CABINET MEMBER FOR TRANSPORT - 24 MARCH 2011

OXFORD, THE SLADE AND HORSPATH DRIFTWAY, CYCLE AND PEDESTRIAN IMPROVEMENTS

Report by Deputy Director of Environment & Economy – Highways & Transport

HORSPATH DRIFTWAY / THE SLADE CYCLE AND PEDESTRIAN IMPROVEMENTS: SUMMARY OF FORMAL CONSULTATION RESPONSES, WITH OFFICER RESPONSES

Project title	The Slade / Horspath Driftway Cycle & Pedestrian Improvements	
Drawing title	Key Features

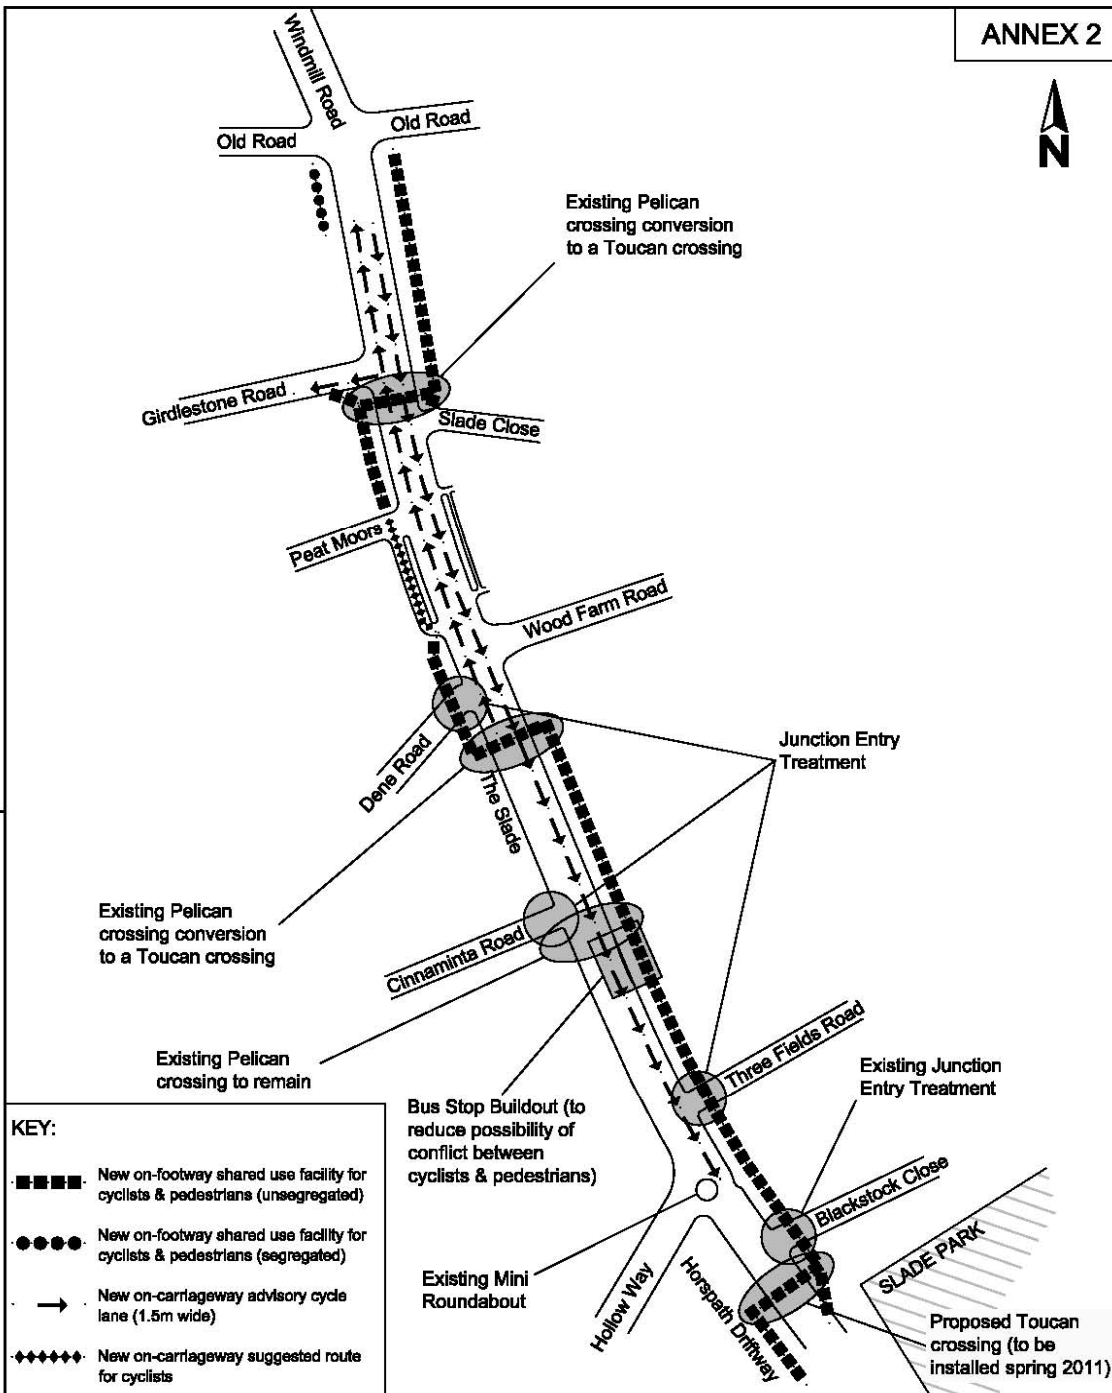
Ref:	Description	Address	Comments	Officer response
1	Local resident	The Slade	<ol style="list-style-type: none"> <li data-bbox="689 368 1272 544">1. In the opinion of the respondent, <i>'The Slade is unsafe for cyclists, and cyclists [currently] have to get off and walk or cycle on the pavement due to the speed of vehicles'</i>. <li data-bbox="689 592 1272 767">2. The respondent commented that <i>'the scheme will help to stop cars parking on the pavements and forcing pedestrians into the road outside number 195 The Slade'</i>. <li data-bbox="689 815 1272 1174">3. The respondent suggested that the scheme should <i>'extend to Old Road heading towards the city centre and Morrell Avenue - [these routes are] wide roads with wide pavements but the roads are very unsafe to cycle on and [road users] should not have to wait for a serious accident involving a cyclist before improvements are made'</i>. <li data-bbox="689 1222 1272 1469">4. A further comment was made concerning the speed of traffic on The Slade and suggested <i>'[reducing] the speed limit on The Slade to 20 mph, or put in speed bumps'</i> (but queried the affect on fire engines and ambulances). 	<p data-bbox="1305 368 2018 440">The scheme would address this by providing safe cycle routes.</p> <p data-bbox="1305 592 1406 616">Noted.</p> <p data-bbox="1305 815 2011 887">The proposals extend to Old Road, and there are separate proposals for a cycle route in Old Road.</p> <p data-bbox="1305 1222 2056 1469">When 20mph limits were introduced across much of Oxford in 2009, The Slade was determined to be suitable for the existing 30mph speed limit to be retained. There are no plans to review this. Vertical deflections on The Slade itself have not been considered as part of this scheme, but the proposals include raised crossings of some side roads, which</p>

Ref:	Description	Address	Comments	Officer response
				<p>would slow turning traffic. Removal of central white line markings and introduction of advisory cycle lanes would visually narrow the road and give drivers a less defined path, with the aim of changing driver perceptions and causing them to moderate their speed.</p>
2	Local residents (2)	The Slade	<p>1. The respondent commented that the <i>'proposed scheme looks great, is well overdue and has our full support'</i>.</p>	Support noted
3	Local resident	Leiden Road	<p>1. The respondent expressed concern over the removal of the right turn lanes into Three Fields and Wood Farm Road, explaining that <i>'traffic gets very congested in that area as there is a lot of parking blocking the left hand lane, therefore removal [of the right turn lane] will increase congestion'</i>.</p> <p>2. The respondent suggested <i>'double yellow lines should be provided at the junction to Three Fields to stop vehicles parking to close to the junction.....and the current proposals make [the situation] worse'</i>.</p> <p>3. Commenting on the proposed raised junction treatment at the Three Fields junction, the respondent said <i>'the raised junction could make [the situation] more dangerous without double yellow lines'</i>.</p>	<p>The scheme proposals would not reduce the overall carriageway width and the centre line would be removed, so when drivers position themselves centrally to turn right, it is likely that vehicles going straight ahead would be able to pass them. The cycle lane is mandatory so drivers could over-run it when a cyclist is not present (as is the case with most other on-carriageway cycle lanes in Oxford).</p> <p>The situation relative to the parking would not be made any worse as a result of this scheme.</p> <p>The proposed change to the junction geometry is more likely to reduce the likelihood of people parking at the junction in Three Fields. Although it could make it easier to park nearer to the junction on the east side of The Slade, parking does not tend to occur on this side.</p>

Ref:	Description	Address	Comments	Officer response
			<p>4. The respondent suggested that the half width yellow box junction across the Three Fields junction should be extended across the full width of The Slade <i>'to encourage drivers to let right-turners into Three Fields'</i>.</p> <p>5. The respondent commented that they had <i>'not seen a great increase in number of cyclists, perhaps not out at the times leaving for lectures'</i>. Respondent asked if a survey to see how volumes have increased has been considered.</p> <p>6. The respondent disagrees in principle with the idea of cyclists and pedestrians sharing the pavements as <i>'many cyclists are inconsiderate to pedestrians'</i>. Commented that <i>'students are adults and should be able to cycle in the road'</i>.</p>	<p>We would monitor the situation and consider introducing parking controls in the future if necessary. The proposals allow for a yellow box across the whole of the junction mouth, to allow clear entry and exit to Three Fields.</p> <p>A cycle count was carried out but a comparison of the situation before and after the development has not been made. If there has not been a significant noticeable increase this would not be a reason not to create the cycle route – part of its purpose is to encourage more cycling.</p> <p>It is true that a small minority of cyclists are inconsiderate to pedestrians, but accidents between cyclists and pedestrians are thankfully very rare. Officers consider that the risk of conflict is very low and does not outweigh the overall benefits of the scheme.</p>

4	Local resident	The Slade	<p>1. The respondent cycles along The Slade to Somerville College most days and considers The Slade to be <i>'very unsafe for cyclists'</i>. The respondent commented that they <i>'often have to get off and walk, or cycle a short way on the pavement, because traffic travels so fast and ignores cyclists'</i>.</p> <p>2. The respondent expressed their <i>'full support for the scheme'</i>.</p>	<p>The scheme would address this by providing safe cycle routes.</p> <p>Support noted.</p>

Ref:	Description	Address	Comments	Officer response
5	Local resident	Inott Furze	<ol style="list-style-type: none"> <li data-bbox="689 263 1288 703">1. The respondent objects to the removal of the right-turn lanes along The Slade explaining that 'they are of great benefit to cyclists who need to turn right across the traffic, the alternative is blocking the traffic behind till the other side of the road clears and motorists get impatient'. Made reference to the existing right turn lane at Peat Moors 'at the top of a short hill and removing it would obviously make turning right difficult. <li data-bbox="689 746 1288 963">2. The respondent considers the right turn lanes as <i>'more important safety features than anything contained in the proposal'</i> and was <i>'amazed to read they 'are not considered essential in safety terms'</i> <li data-bbox="689 1007 1288 1369">3. The respondent commented that <i>'there is not room on the pavement for safe sharing with cyclists, allowing cyclists to ride on pavements is just a way of getting them off the road at the expense of pedestrians, safe sharing means pedestrians getting out of the way of bikes, often by stepping off the kerb which bikes can't do once committed to the pavement'</i>. <li data-bbox="689 1412 1288 1473">4. The respondent considers <i>'pavement cycle ways also cause problems for on</i> 	<p data-bbox="1310 263 2087 408">The scheme proposals would not reduce the overall carriageway width so when cyclists position themselves to turn right, vehicles going straight ahead will still be able to pass them.</p> <p data-bbox="1310 708 2087 853">If right turn lanes were considered essential they would need to be introduced at every junction, and this is clearly not the case. In fact there are many busy junctions on urban roads without them.</p> <p data-bbox="1310 930 2087 1331">The available footway widths are above the Department for Transport recommended minimum widths for shared use cycle paths. It is not our purpose to remove cyclists from the road if they wish to cycle on the road. This is demonstrated by the introduction of on-carriageway cycle lanes for the more confident cyclist. Pedestrians still have priority on the footway and most cyclists will slow down and give way to pedestrians, not wanting to risk a collision. The footway widths allow pedestrians and cyclists to safely avoid one another.</p> <p data-bbox="1310 1412 2087 1473">In this situation the cyclist on the road would have overtaken the cyclist on the footway and so would be</p>

Ref:	Description	Address	Comments	Officer response
			<p><i>road cyclists who have to try and check behind their shoulder for pavement cyclists speeding up the inside before they can turn left'.</i></p> <p>5. Pavement cyclists are not necessarily slower and, as less experienced cyclists, they often have no concept of when to watch out for and give way to road cyclists and traffic.</p> <p>6. The respondent suggested a cycle route through the residential streets of the new Eastfield Estate to Holloway could be promoted for 'less experienced cyclists'.</p> <p>7. However, the respondent does agree with the provision of the crossing [on Horspath Driftway?].</p>	<p>aware of the risk. In any case, turning cyclists should always check for pedestrians on the footway and would be unlikely not to notice a cyclist about to cross.</p> <p>See above comment – it is assumed that cyclists on the road would be more experienced and look out for them.</p> <p>There is no available link between East Field Close and Hollow Way.</p> <p>Noted.</p>

6	Local resident	The Slade	<p>1. The respondent supported the new Toucan crossing and bus stop markings on Horspath Driftway.</p> <p>2. Concern was expressed regarding the <i>'removal of [right turn lane] road markings on The Slade as a lot of traffic turns right at the Wood Farm Road'</i>. The respondent is of the opinion that if the existing right turn lane were to be removed to accommodate the proposed cycle</p>	<p>Noted.</p> <p>The scheme proposals would not reduce the overall carriageway width and the centre line would be removed, so when drivers position themselves centrally to turn right, it is likely that vehicles going straight ahead would be able to pass them. The cycle lane is mandatory so drivers could over-run it when a cyclist is not present (as is the case with most other on-carriageway cycle lanes in Oxford).</p>

Ref:	Description	Address	Comments	Officer response
			<p>lanes <i>'any vehicle turning will hold up the traffic behind it until a vehicle coming in the opposite direction allows it to cross at many hours of the day there is no break in the traffic'</i>.</p> <p>3. The respondent commented that by providing cycle lanes <i>'there is a great danger of cyclists coming fast up the inside and being invisible to turning traffic'</i>.</p> <p>4. The respondent commented that he thought the localised footway build out at the junction between The Slade and Peat Moors service road was <i>'a large expense for an occasional problem'</i>. The respondent queried whether road markings could be used instead to achieve the same result.</p> <p>5. The respondent was unconvinced by the <i>'expense of raised entries, where vehicles lurch as they find it difficult to get the right acceleration when they have to cross them and make the road/path less safe for pedestrians'</i>.</p> <p>6. The respondent questioned the gap between the proposed bollards at the alley way cut throughs on the east side of The Slade, making particular reference to <i>'sufficient [width] for</i></p>	<p>(3) This is a risk at junctions, but one that most cyclists are aware of, particularly when passing queuing traffic. At junctions without yellow boxes the cycle lane is marked across the junction mouth, making drivers aware of the cycle lane as they turn. The yellow box junction with Wood Farm Road has a wide mouth and therefore good visibility between oncoming cyclists and right turning cyclists. The yellow box junction at Three Fields could be extended to improve visibility, but the raised entry treatment would in any case slow turning traffic.</p> <p>(4) There is a high level of parking demand in this service road, with vehicles frequently parking on the corner. A build out would physically prevent this and allow cyclists space to enter the service road from the footway.</p> <p>(5) The gradient of the raised entry treatment would not be steep enough to cause this to happen.</p> <p>Widths have been checked and are in accordance with the Department for Transport's 'Inclusive Mobility' guidance document.</p>

Ref:	Description	Address	Comments	Officer response
			<p><i>unmounted bicycles and electric scooters as this route can be used instead of the main road?</i></p> <p>7. The respondent questioned the business case for progressing with the scheme [Section 106 money].</p> <p>8. Questioned if OCC were going to liaise with Oxford Brookes University to promote cycling when the scheme is Implemented.</p>	<p>The relevant S106 contribution is restricted to providing a safe cycle route between Slade Park and Oxford Brookes University Campus. The scheme is fully funded from developer contributions thus does not place a burden on other funding sources or detract from the council's ability to spend on other items. Oxford Brookes University does promote cycling, and the county council supports them in this.</p>
7	Relative of local resident		<p>1. Sent in on behalf of the respondent's father. The respondent expressed concern regarding the two sections of proposed unsegregated footway/cycle route near Girdlestone Road and Dene Road <i>'as it will put the most vulnerable pedestrians at risk from cyclists'</i>. The respondent's father is blind and walks from The Slade to Old Road on a daily basis. According to the respondent, the proposals will <i>'cause [her father] difficulty and increased stress'</i>.</p> <p>2. The respondent finds the shared facilities <i>'stressful due to the high speed of cyclists'</i>. The respondent commented that <i>'the visually impaired do not have the luxury of walking in the road or moving to allow cyclists to pass. Other vulnerable people such as</i></p>	<p>Officers accept that there is a risk that shared use cycle tracks can be intimidating for blind people and those with low vision. However, the scheme has been carefully designed, following Department for Transport Guidelines, to ensure adequate footway widths and visibility (in this case the cyclist being able to see the pedestrian). This issue is further discussed in Annex 5 of this report.</p> <p>Officers also recognise the potential impact on elderly and disabled people. Again, this is further discussed in Annex 5 of this report.</p>

Ref:	Description	Address	Comments	Officer response
			<p><i>the elderly, people with buggies and people with disabilities will be at greater risk from being hit and will also feel intimidate by cyclists'.</i></p>	
8	Relative of local resident		<ol style="list-style-type: none"> 1. Sent in on behalf of the respondent's ex-husband. The respondent expressed concern about the two proposed unsegregated cycle routes on the pavement near Girdlestone Road and Dene Road as <i>'they will put the most vulnerable pedestrians at risk from cyclists'.</i> 2. The respondent commented that her ex husband is blind and walks from The Slade to Headington daily, a journey which <i>'he already finds difficult, due to parked cars blocking footways, abusive cyclists who already use the pavement and other similar obstacles'.</i> In the respondent opinion <i>'the elderly and mothers with young children experience similar problems'.</i> 3. The respondent's view is that <i>'cycle paths should not be [provided] at the expense of the pedestrian. The designation of parts of a pavement as unsegregated cycle/pedestrian routes will prevent the vulnerable.....from using these footpaths as they will lack the confidence to use them'.</i> 	<p>Officers accept that there is a risk that shared use cycle tracks can be intimidating for blind people and those with low vision. However, the scheme has been carefully designed, following Department for Transport Guidelines, to ensure adequate footway widths and visibility (in this case the cyclist being able to see the pedestrian). This issue is further discussed in Annex 5 of this report.</p> <p>Officers also recognise the potential impact on elderly and disabled people. Again, this is further discussed in Annex 5 of this report.</p>

Ref:	Description	Address	Comments	Officer response
9	Oxford resident	Church Cowley Road	<ol style="list-style-type: none"> <li data-bbox="689 263 1288 560">1. The respondent commented that <i>'as a cyclist I will not use shared-use pavements, because they have to give way to everything and are therefore slower. They also encourage drivers to think cyclists have no right to be on the road.....and are dangerous for pedestrians'</i>. <li data-bbox="689 596 1288 845">2. The respondent expressed concern that shared use footways would be open to use by all cyclists and not just the less confident ones and concluded that <i>'shared use pavements are also likely to make the problem of illegal pavement cycling worse'</i>. 	<p data-bbox="1310 263 2087 411">Cycle routes on the footway are intended for less confident and slower cyclists. The scheme would provide on-carriageway cycle lanes for more confident cyclists along much of The Slade.</p> <p data-bbox="1310 596 2063 815">It is true that the facilities would be open to use by all cyclists but cyclists wishing to go fast are likely to choose the on-carriageway lane. Officers do not believe there is strong evidence that clearly marked, official shared use footways encourage more illegal footway cycling elsewhere.</p>

10	Manager of Oxford Options Resource and Wellbeing Centre		<ol style="list-style-type: none"> <li data-bbox="689 858 1288 1181">1. The respondent expressed full support for the provision of cycle lanes. The remainder of the respondent's comments related to the installation of a bus stop on Horspath Driftway and suggested it could have been located closer to the Oxford Options Resource and Wellbeing Centre located on Agwar Stone Road. 	<p data-bbox="1310 858 2063 927">Comments noted. The bus stop has been positioned where there is the greatest demand for the service.</p>
11	Cyclox		<ol style="list-style-type: none"> <li data-bbox="689 1193 1288 1337">1. Responding on behalf of Cyclox, the respondent stated that <i>'in principle, we are glad to see cycle lanes, and a general use of unsegregated footway'</i>. <li data-bbox="689 1374 1288 1476">2. The respondent also stated general support for the introduction of the section of segregated footway at the 	<p data-bbox="1310 1193 1406 1225">Noted.</p> <p data-bbox="1310 1374 1406 1406">Noted</p>

Ref:	Description	Address	Comments	Officer response
			<p>Windmill Road / Old Road signal controlled junction.</p> <p>3. Support was also given for the new road markings at the Hollow Way roundabout (Slade approach), but was qualified with the suggestion of <i>'marking cycle lanes on the other two corners [of the roundabout]. There can be a cycle lane from the roundabout to just past Three Fields - there is little demand for parking on this stretch'. [east side of The Slade].</i></p> <p>4. Further suggestions were made by the respondent as follows:</p> <ul style="list-style-type: none"> • dropped kerbs at the ASL located on The Slade (Windmill Road junction) should extend across the full length of the lead-in lane and the full length of the ASL. • Large cycle logos in the left hand on the road <i>'to encourage appropriate motorists.....and to encourage cyclists to take the lane'</i> 	<p>Informal, daytime parking on this stretch does present a problem. For cyclists coming from Hollow Way, there is an alternative, parallel route via Bulan Road. Cyclists coming from Horspath Driftway can use the new Toucan crossing and the off-carriageway facility.</p> <p>Dropped kerbs will cover the length of the lead-in taper and just over half the length of the ASL, an overall length of 6.00 metres. This provides a generous length of dropped (flush) kerbs for cyclists using the off-carriageway facility to drop back into the ASL, including situations when cars are stopped for the traffic signals. Providing a longer length of dropped (flush) kerb would require additional road drainage gullies.</p> <p>Queueing traffic would cover the markings when they would be most useful. They would increase road marking clutter. The symbols may also give the impression that the left turn filter lane was intended for cyclists only (because this lane is only 2.50 m wide).</p>

Ref:	Description	Address	Comments	Officer response
			<ul style="list-style-type: none"> • Removal of the kink in the alleyway (adjacent Dene Road) through to Leiden Road to 'provide a clear link from those roads to the new cycle route' • A cycle lane across the mouth of Cinnaminta Road (from the start of the double yellow lines opposite the bus stop to the bus stop) • Consider marking a <i>'cycle lane despite the parking on the south side [of The Slade] perhaps a 2m [wide] cycle lane with 1m painted build outs or [access protection] bars across driveways'</i> 	<p>This alleyway is not sufficiently wide to allow safe cycling.</p> <p>See response to point 3 above. There is also a bus stop immediately adjacent to Cinnaminta Road.</p> <p>If the purpose of this is to provide a cycle lane past parked cars, it assumes they are parking on the footway (which we would not want to encourage) and even if they are, it is questionable whether there would be sufficient safe space for cycles. In any case, cyclists may want to be well out into the road, away from opening doors. Drivers can often wrongly expect cyclists to stay in their lane, which can be intimidating for cyclists wanting to take a position further out into the road.</p>

12	Oxford resident		<ol style="list-style-type: none"> 1. The respondent objected to the removal of the right turn lanes on The Slade on the basis that <i>'traffic will not have a marker for the correct positioning to allow traffic to pass besides them, to leave room for all traffic approaching'</i>. 2. The respondent commented specifically about Cinnaminta Road <i>'where traffic is over the centre line in order to pass parked cars'</i>. On the 	<p>Most drivers would be able to judge the suitable road position, particularly when they became accustomed to the route.</p> <p>Parking less than 10m from a junction is contrary to the Highway Code. Removing guard rail would make it easier for someone to park so as to cause an obstruction, but the risk would be outweighed by the</p>

Ref:	Description	Address	Comments	Officer response
			<p>removal of the pedestrian guard railing at Cinnaminta Road, the respondent commented <i>'by removing the railings how will [the] scheme prevent more obstructive parking [at this location]?'.</i> The respondent observed that <i>'parking at the corner of Cinnaminta Road / The Slade is a significant hazard even though the railings are meant to preclude this'.</i></p> <p>3. The respondent expressed his general concern with the removal of the centre lines on The Slade as in the opinion of the respondent they assist with correct positioning for turning traffic.</p> <p>4. Commenting on the proposals for the Girdlestone Road junction area, the respondent suggested providing a new diagonal link across the open ground to the south of the junction in order to make a more convenient route for cyclists'. The respondent suggested that the southern corner of this junction be widened to assist buses turning left into Girdlestone Road.</p>	<p>potential benefits to pedestrians. The provision of a raised crossing area and tightening the corners would help deter parking on the corner.</p> <p>Most drivers would be able to judge the suitable road position, particularly when they became accustomed to the route.</p> <p>This has been investigated but the landowner has not given permission.</p> <p>The mouth of the junction is already wide and widening it further would make it harder for pedestrians to cross and increase the possibility of conflict with cyclists.</p>

13	On behalf of Unlimited		<p>The respondent:</p> <p>1. asserts that the only people to benefit from the proposal will be the students in Slade Park;</p>	<p>The benefits of the scheme would be much wider and are discussed fully in the report.</p>

Ref:	Description	Address	Comments	Officer response
			<ol style="list-style-type: none"> 2. asserts that students are adults and therefore should be able to cycle safely on the road – also that they do not need to cycle at peak traffic times; 3. is concerned that the footway is narrowed in places by the presence of street furniture, and that there will be insufficient space around the bus stop; 4. is concerned about people with low vision/hearing disability who may not detect an approaching cyclist; 5. is concerned about sight lines at exits from properties being obscured by hedges; 6. is concerned about people with disabilities and mobility impairment avoiding The Slade, and the risk that this would reduce their independence; 7. asserts that ‘young, healthy able bodied people are being given priority above those vulnerable members of our community who deserve recognition’; 	<p>Just because they are adults does not mean that they are experienced or confident cyclists. Many students do in fact need to travel to lectures and other teaching during peak times.</p> <p>The design takes account of this, and street furniture would be moved where necessary. The footway would be widened sufficiently at the bus stop.</p> <p>Officers accept that there is a risk that shared use cycle tracks can be intimidating for blind people and those with low vision, as well as people with other disabilities, including hearing loss. However, the scheme has been carefully designed, following Department for Transport Guidelines, to ensure adequate footway widths and visibility (in this case the cyclist being able to see the pedestrian). This issue is further discussed in Annex 5 of this report.</p> <p>The risk to vulnerable road users is very low and needs to be considered in conjunction with the wider benefits of the scheme, discussed in the report. Aspects of the design such as raised side road entry treatments improve conditions for elderly or physically impaired pedestrians</p>

Ref:	Description	Address	Comments	Officer response
			8. and suggests that students should instead be educated to ride safely and responsibly.	The Universities promote safe cycling and Oxford Brookes University has previously offered cycling training and has plans to do so in the future.
14	Local City Councillor Bob Timbs		Respondent does not have any problems with the proposed cycle facilities and has had no complaints from residents. He has concerns about parking in Blackstock Close.	Support noted. Parking in Blackstock Close is being monitored.
15	Local County Councillor Val Smith		Very happy with the proposals.	Support noted.
16	Travel Choices Team, Oxfordshire County Council		<p>The respondent:</p> <ol style="list-style-type: none"> 1. shares concerns about shared use footways, but accepts the limitations of on-road facilities in this location; 2. has concerns that the footway is narrowed in places by obstructions such as signs; 3. proposes road markings, signs and information should make it clear that pedestrians have priority on shared use footways; 4. suggests that seating is improved in the bus shelter; 	<p>Noted.</p> <p>Street furniture including signs would be moved as necessary – this has been allowed for in the design.</p> <p>The county council is restricted to using Department for Transport approved signage. However, additional markings on the footway could be considered.</p> <p>Replacement of the bus shelter is out of scope, as it would not be affordable within the scheme budget.</p>

Ref:	Description	Address	Comments	Officer response
			<p>5. is concerned about drainage leading to ponding on the west side of The Slade;</p> <p>6. welcomes the removal of guard rail at Cinnaminta Road;</p> <p>7. suggests installing new seating on the route;</p> <p>8. suggests signage in the service road warning motorists of the presence of cyclists.</p>	<p>Comment noted – this is a matter for maintenance, except at locations where the scheme involves moving the kerblines, where drainage has been taken into consideration.</p> <p>Support noted (6).</p> <p>Regretably this is not affordable within the scheme budget.</p> <p>Cycle symbols could be painted on the carriageway.</p>
